MEMORANDUM

Project: Otay Ranch Village 14 & Planning Areas 16/19

Subject: Roundabout Conceptual Review

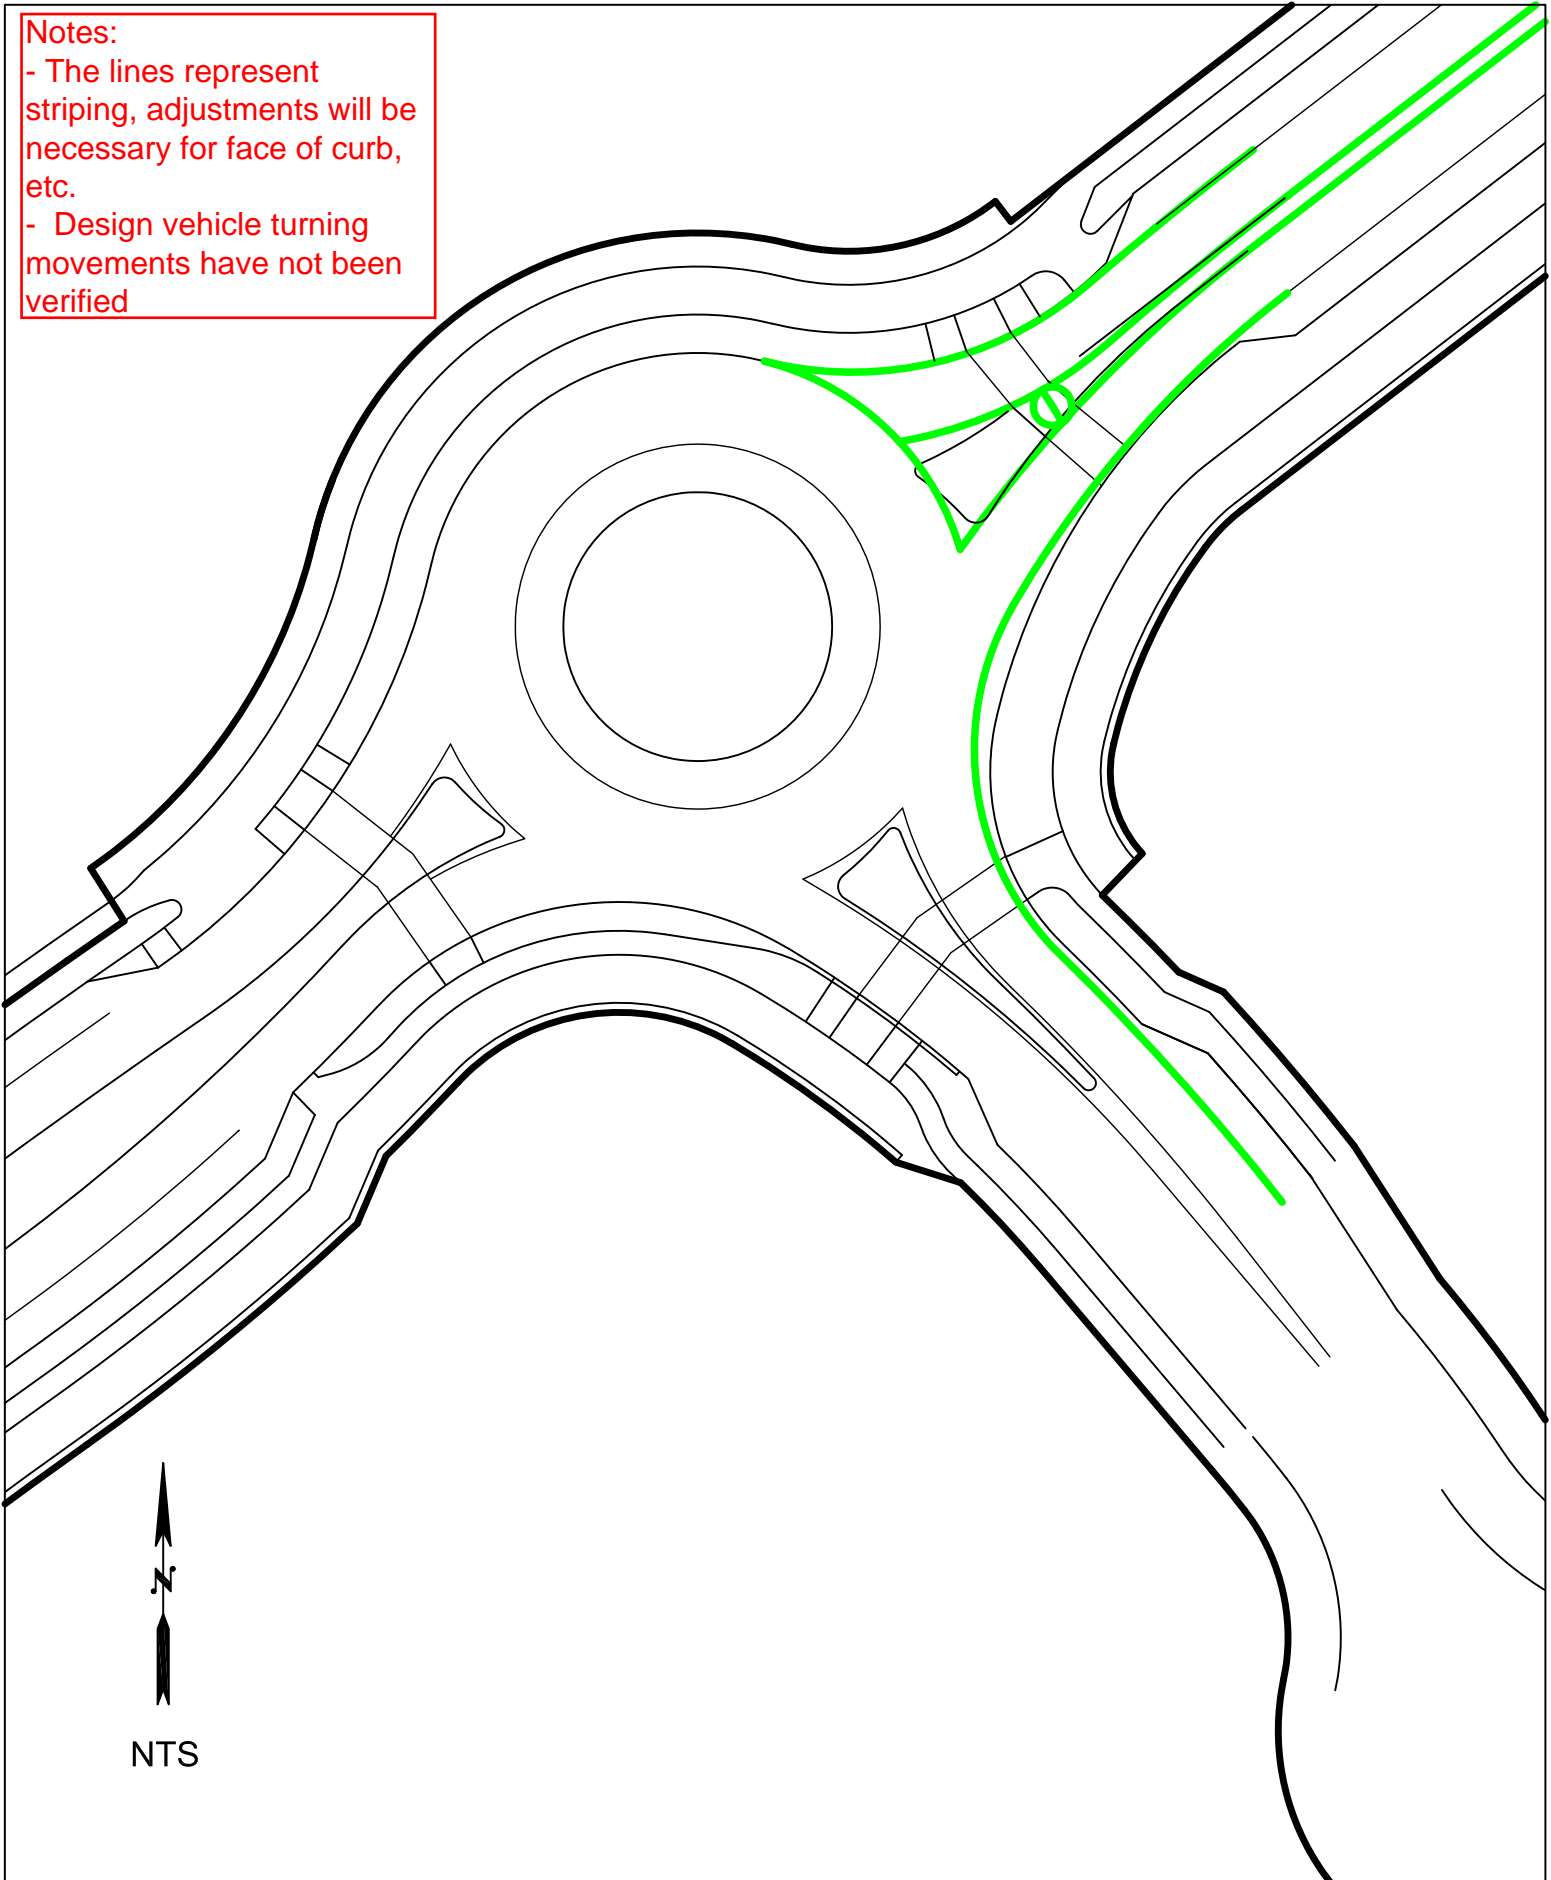
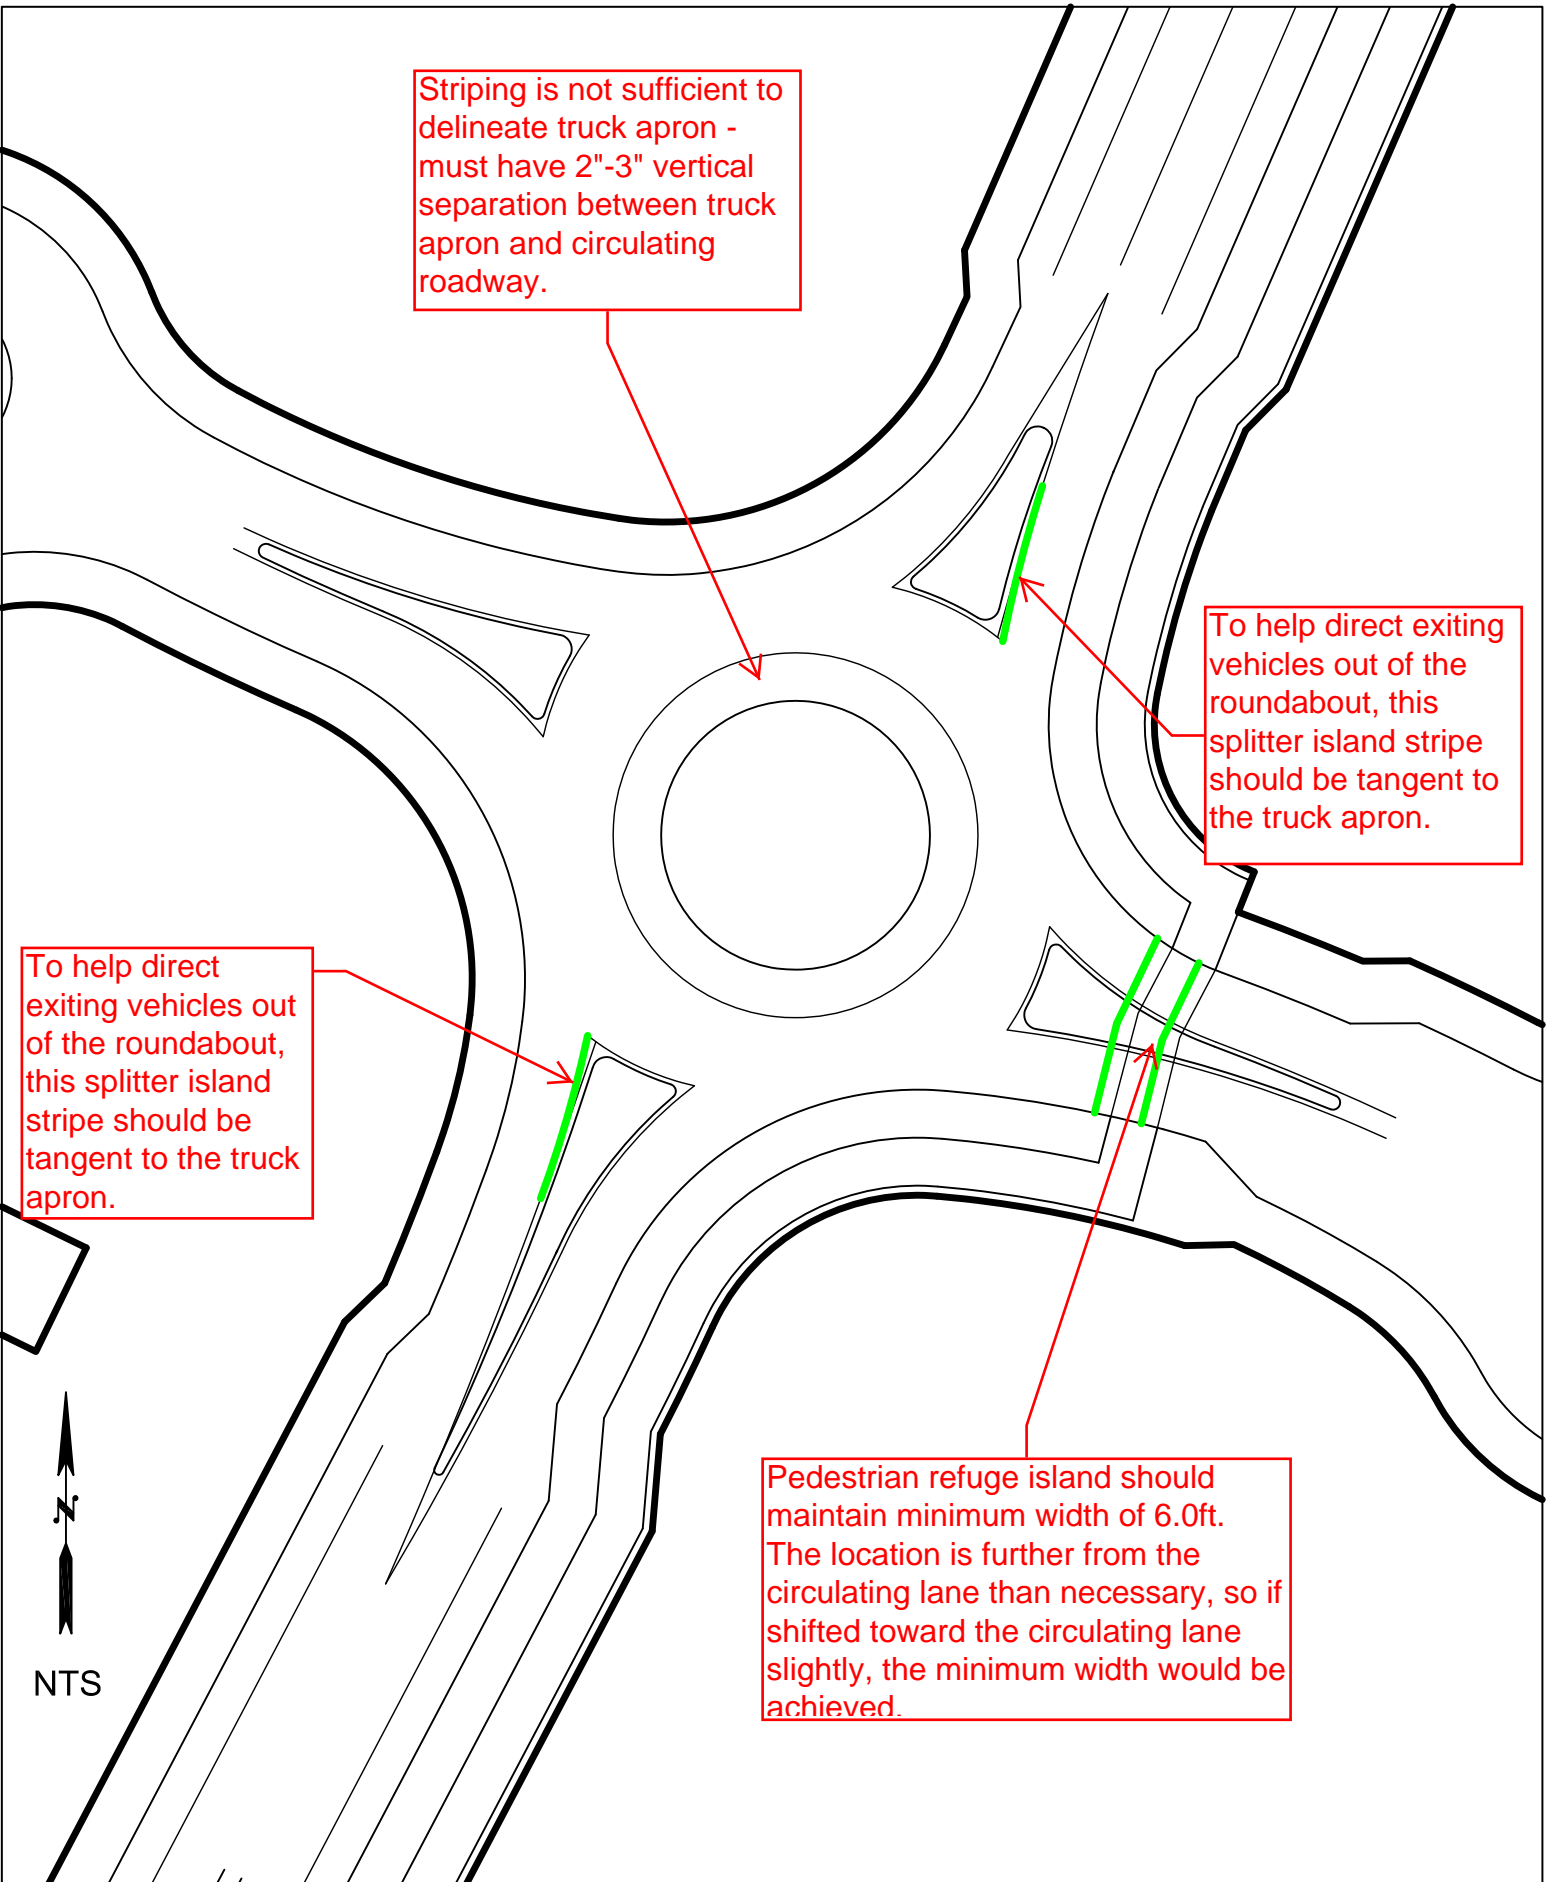
Notes:
- The lines represent striping, adjustments will be necessary for face of curb, etc.
- Design vehicle turning movements have not been verified

Striping is not sufficient to delineate truck apron - must have 2"-3" vertical separation between truck apron and circulating roadway.

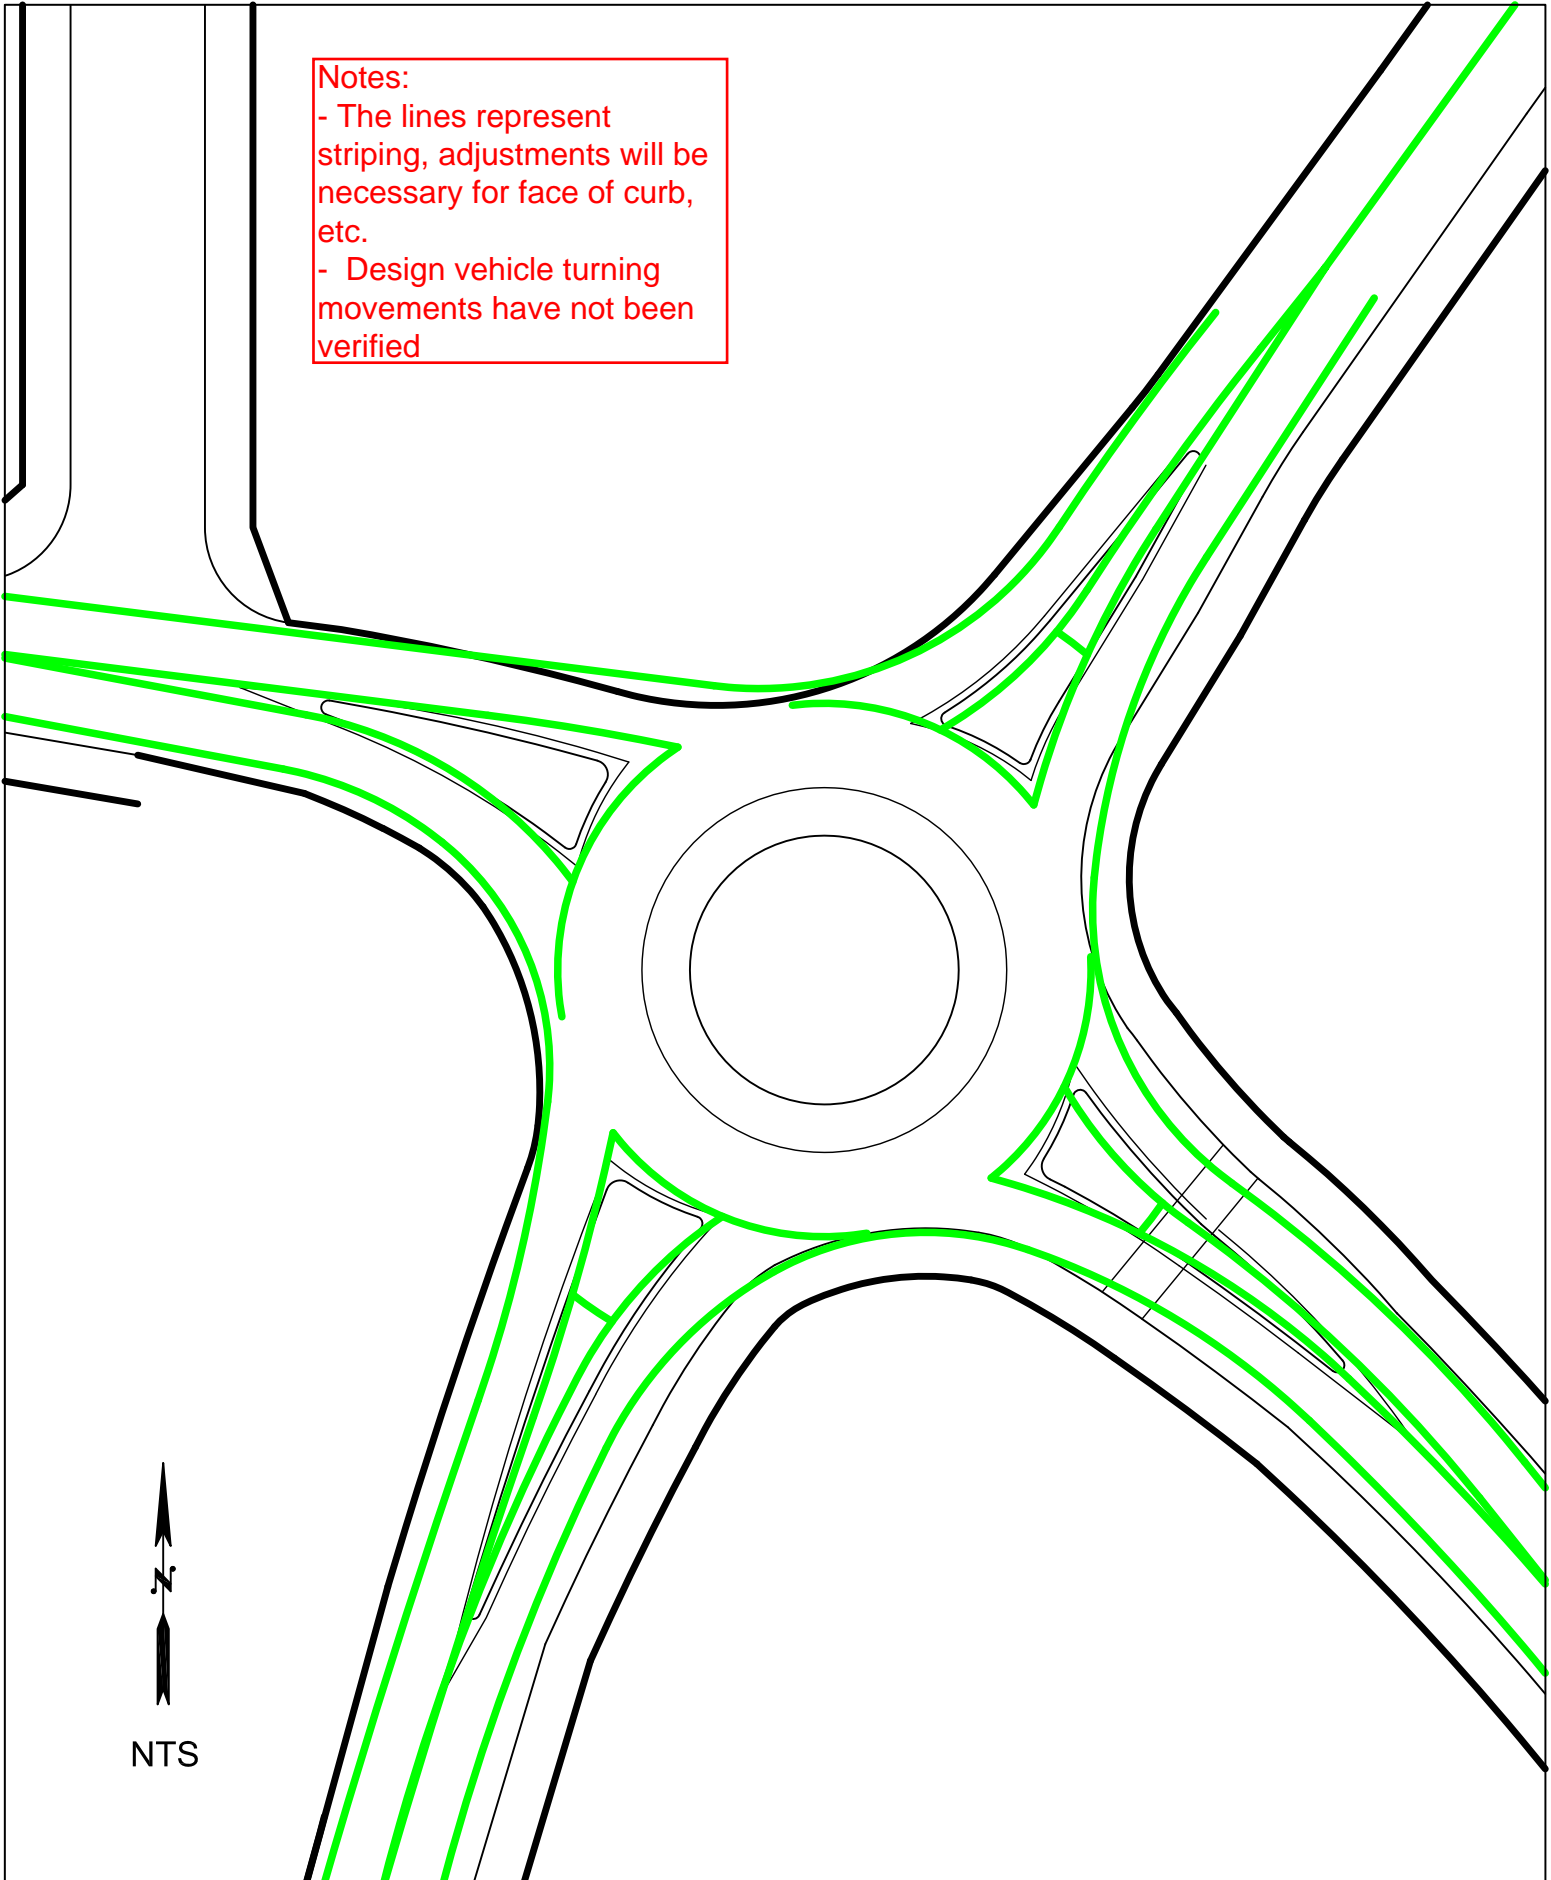
Entry speed is over 30mph (23mph is acceptable). The splitter island is not directing vehicles into circulating lane

The splitter island should be tangent to truck apron on exit and entrance to influence drivers sufficiently. All four splitter islands are lacking.

Deflection of splitter island is not sufficient

See Figure 5a for revised geometry that addresses these concerns
